20LC-003

STAFF REPORT

2017 Avenue N 1/2

Certificate of Appropriateness in order to add shutters on three (3) windows

ATTACHMENT A

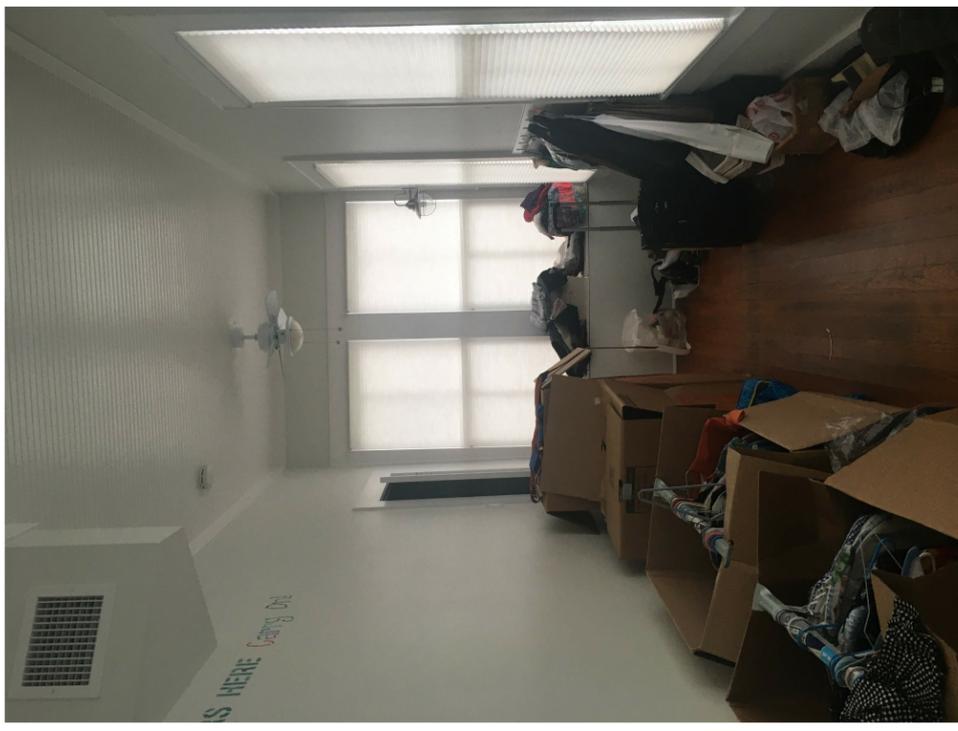
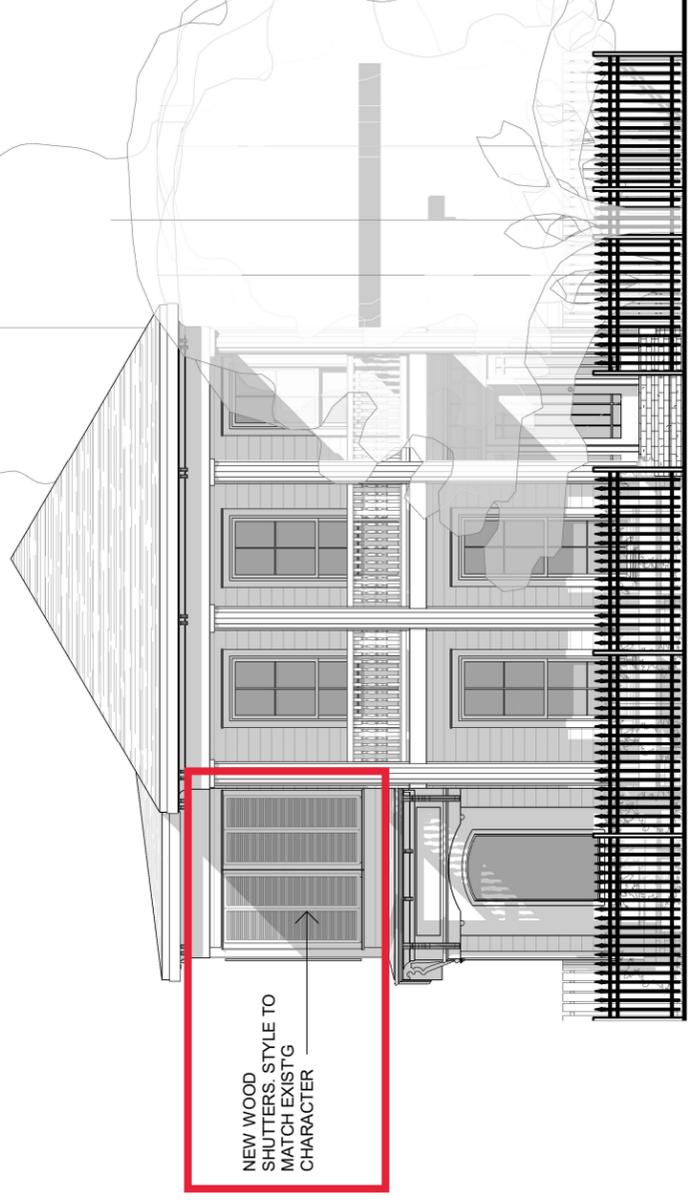
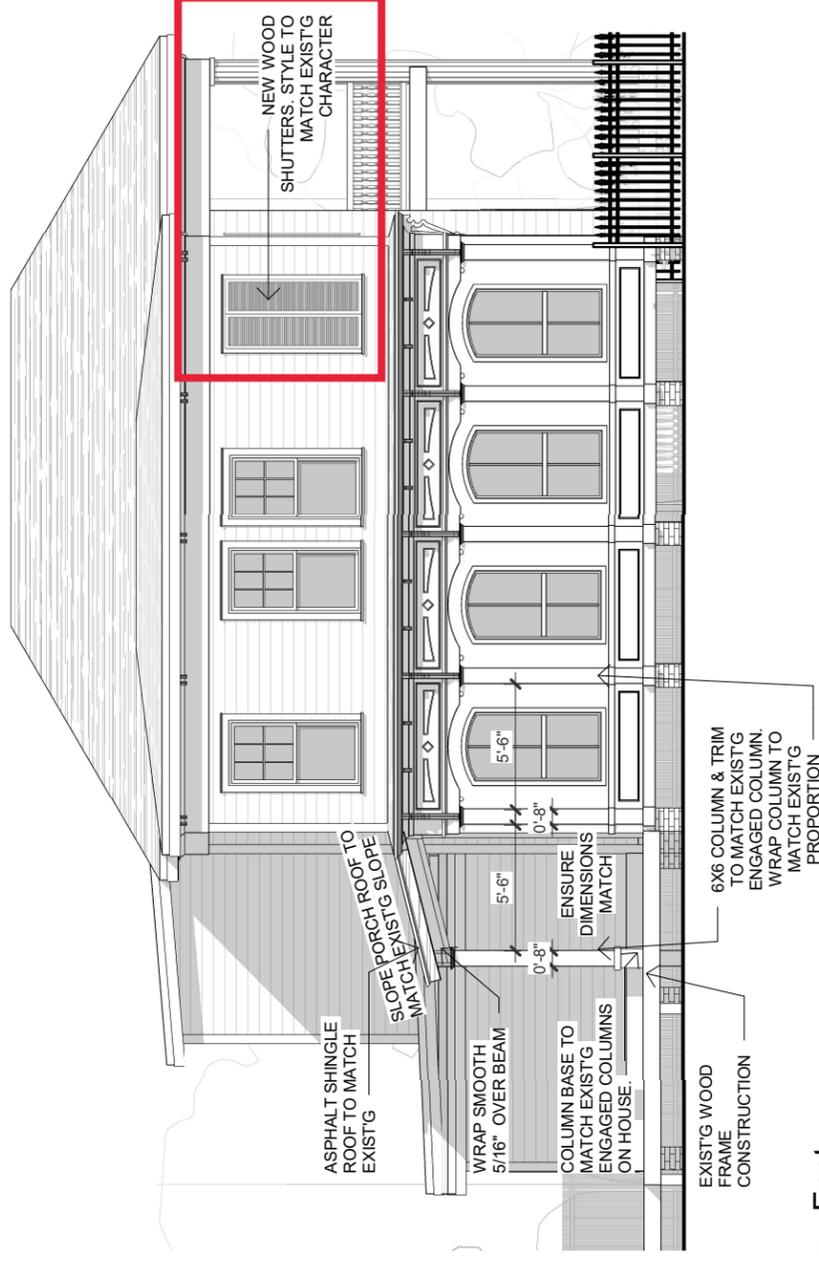
The applicant is requesting a Certificate of Appropriateness to add shutters to three (3) windows. These windows are on the northeast (front) corner of the house and open into a remodeled bathroom. The shutters will be placed as shown in Attachment A.

Staff finds that the request generally conforms to the Design Standards. While shutters do not exist on any other part of the house, the proposed shutters do match the overall character of the house and the proposed style and dimension are appropriate. The shutters do not significantly alter the appearance and character of the house, and are easily removed later if desired. Finally, the shutters do serve to provide privacy to the upstairs bathroom the applicant intends to add, while retaining the existing larger windows.

1. The exterior modifications shall conform to the design, materials, and placement in Attachment A of the staff report;
